Response to Opinion ABP.Ref. 308186-20

Tack Sandyford SHD

**Strategic Housing Development for Build
to Rent apartment development for 207
units at Ravens Rock Road/ Carmanhall
Road, Sandyford, Dublin 18**

Figure 1: Tack-Avid Masterplan urban design analysis from MDO Design Statement

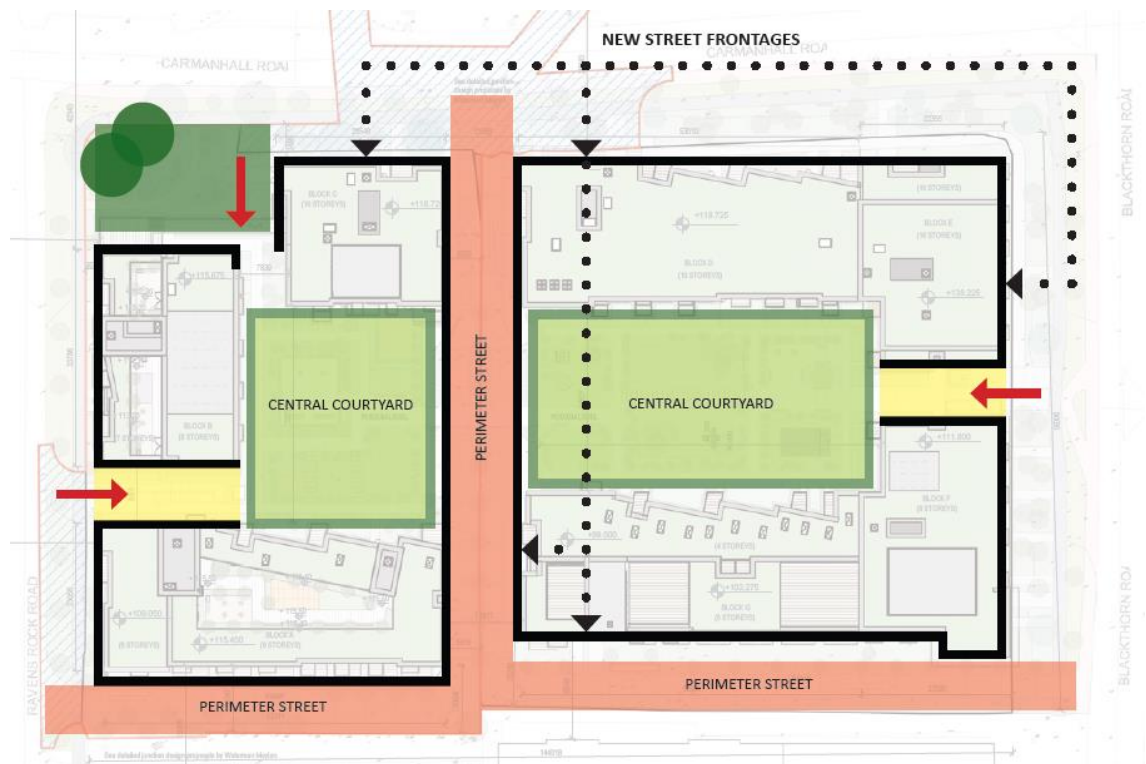
The approach and primary access to Block A and B is provided from Ravens Rock Road and to Block C from Carmanhall Road. A level entry to the communal courtyard has been provided from a gated, passage between Block A & B. A significant change in levels along Ravens Rock Road elevates the courtyard to the first floor around the Pocket Park in the north corner of the site and allows to enjoy the view of well landscaped public open space from residents' only terrace.

The Design Report by MDO provides detailed analysis of the urban design rationale for the layout of the proposed development considered in the broader context of a masterplan with the adjoining Avid site.

Figure 2: Access and Circulation analysis by NMP Landscape Architects', Landscape Design Statement

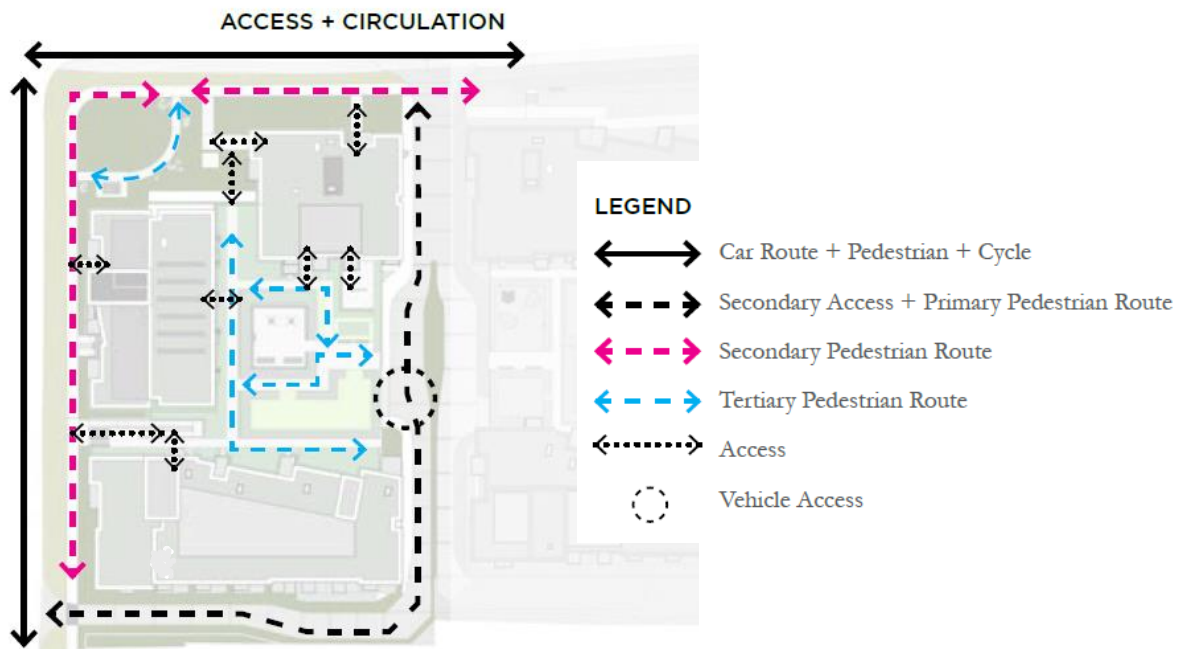
A one-way traffic arrangement is proposed on the site with the entry of Ravens Rock Road and exit to Carmanhall Road to reduce the size and impact of the proposed junctions and to allow the permeability of the site and vehicular access for fire tender and services as well as to the residents only car park.

Figure 7: Illustration of location of Shared Amenity Spaces and Creche at Lower Ground and Ground levels from MDO Design Statement

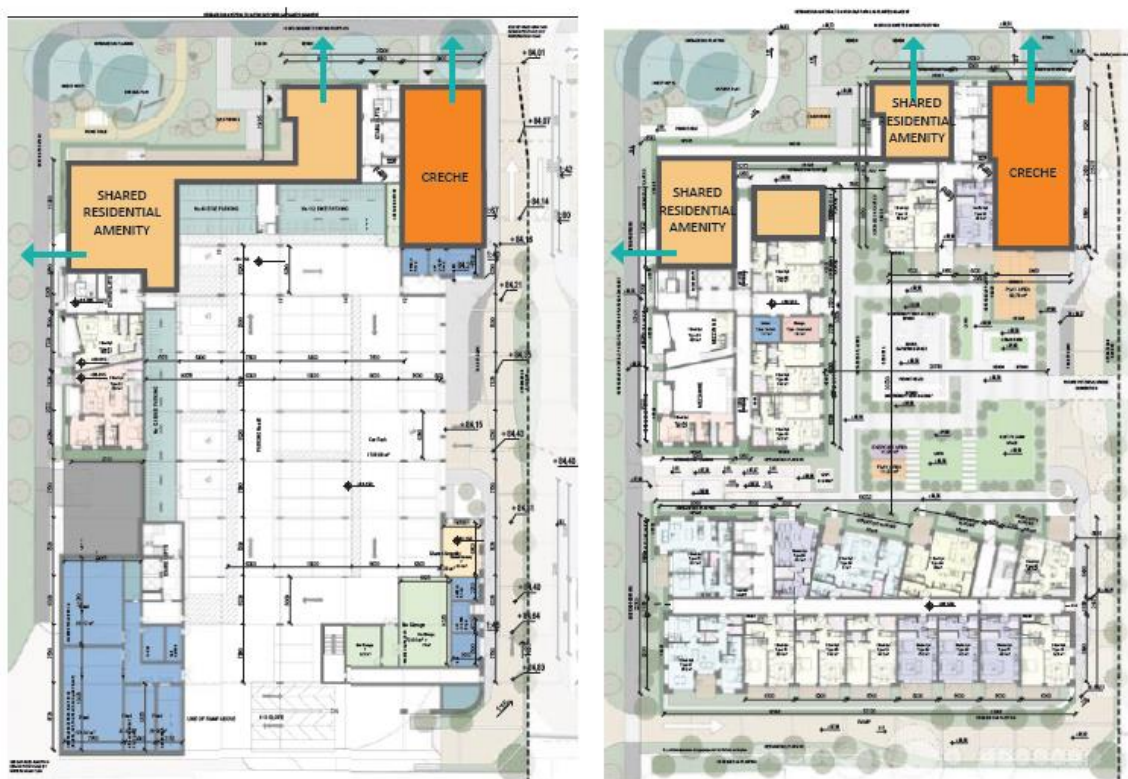
2. Detail and justification of location and quantum of resident support facilities and resident services and amenities as defined by the Sustainable Urban Housing Design Standards for New Apartments Guidelines (2018) and accessibility/ease of access to those spaces by future residents.

It highlights that the development has been designed with quality of amenity space as a central consideration for both residents and the wider community. It is proposed to provide 415 sqm of high quality shared residential amenities in Blocks A, B and C, 2 sqm/residential unit. The proposed shared residential amenities include a resident’s lounge, co-working spaces, meeting room, children indoor play area, and a library.

Additional uses and facilities provided in the scheme include a communal garden courtyard, children’s playground, and several shared residential amenities, all of which can be easily accessed by residents. The central garden courtyard will be located at ground floor level podium covering the car park and can be used as an outdoor amenity space which is safe and passively overlooked.

Figure 8: Extract from Landscape layout drawing by NMP Landscape Architects

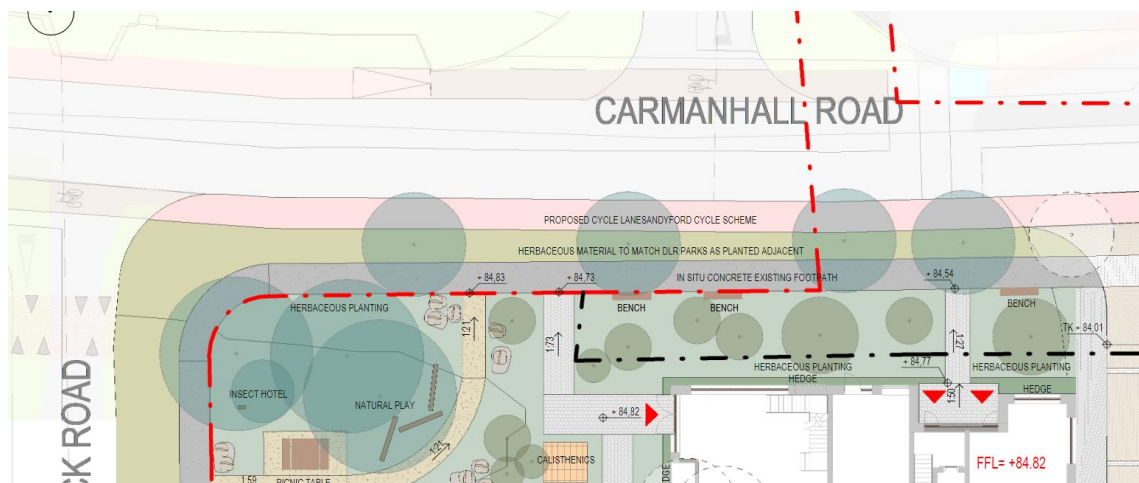
3. Further detail and consideration of works required to the public realm, including the 'linear greenway' required under the SUIP along Carmanhall Road and footpath network along Ravens Rock Road, including a letter of consent from the planning authority in relation to any areas in their ownership.

The Landscape Design Report and Landscape Drawings prepared by NMP Landscape Architects provides detailed plans, sections and design information on proposals for the interface between the public roadway, verges and building frontage. This was discussed on-site with the Senior Parks Superintendent and NMP Landscape Architects.

DLR has invested in a high quality planning scheme in the verge and it is the overall landscape strategy to preserve DLR's planting strip and complement the Council's approach and replenish verge planting as appropriate (at old site access locations for example).
